Access Compliance Report

Public Rights-of-Way

(Curb Ramps)

Intersection ID: 2896	Main Street: ALLNESS_GLEN_LN	Cross Street: HARBURN_FOREST_DR	Location: SW
ADA ID: 6F3A9AEB297D	Ramp Type: PerpDiag	Initial Pass/Fail: Fail	Overall Compliance: No
Severity Score: 35			
Codes/Mitigation Info/Possible Solution		Field Measurements/Component Compliance

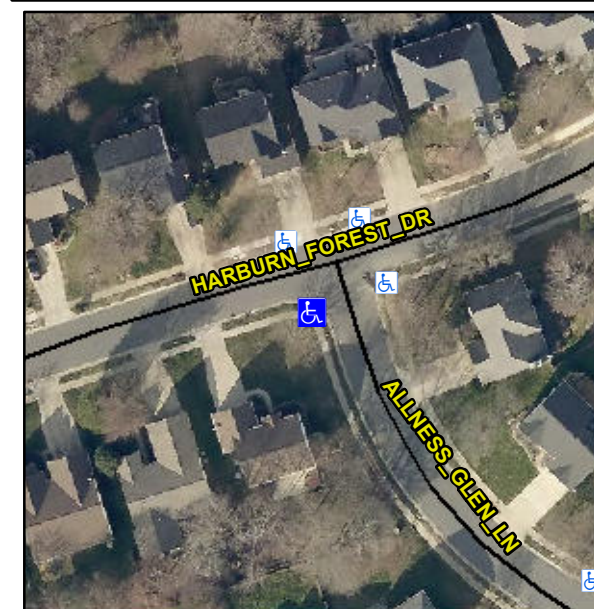
Not Found, R304.5.1, R304.2.2, R304.5.3

Compliance	Description	Data	Compliance	Description	Data
N/A	Ramp Length (in)	43.5	No	Ramp Slope (%)	12.6
No	Ramp Width (in)	47.0	No	Ramp XSlope (%)	4.7
N/A	Flare Type LT	N/A	N/A	Flare Type RT	N/A
N/A	Flare Slope LT (%)	N/A	N/A	Flare Slope RT (%)	N/A
N/A	Flare Traversable LT?	N/A	N/A	Flare Traversable RT?	N/A
N/A	Landing Length (in)	N/A	N/A	DWS Provided?	N/A
N/A	Landing Width (in)	N/A	N/A	DWS Contrast?	N/A
N/A	Landing Slope (%)	N/A	N/A	DWS Length (in)	N/A
N/A	Landing X Slope (%)	N/A	N/A	DWS Full Width?	N/A
N/A	Landing Curb? (Y/N)	N/A	N/A	DWS Offset (in)	N/A
N/A	Shared Landing?	N/A			
N/A	Gutter Ponding?	N/A	N/A	Gutter Slope (%)	N/A
N/A	Gutter Lip Ht (in)	N/A	N/A	Gutter X Slope (%)	N/A
N/A	Painted X Walk1?	No	N/A	Painted X Walk2?	No
	X Walk 1 Direction	To E		X Walk 2 Direction	To N
N/A	X Walk 1 Width (in)	N/A	N/A	X Walk 2 Width (in)	N/A
	X Walk 1 Slope (%)	2.8		X Walk 2 Slope (%)	2.9
	X Walk 1 X Slope (%)	3.6		X Walk 2 X Slope (%)	1.4

Remove & Replace Curb Ramp With Two New Directional Ramps or Equivalent.
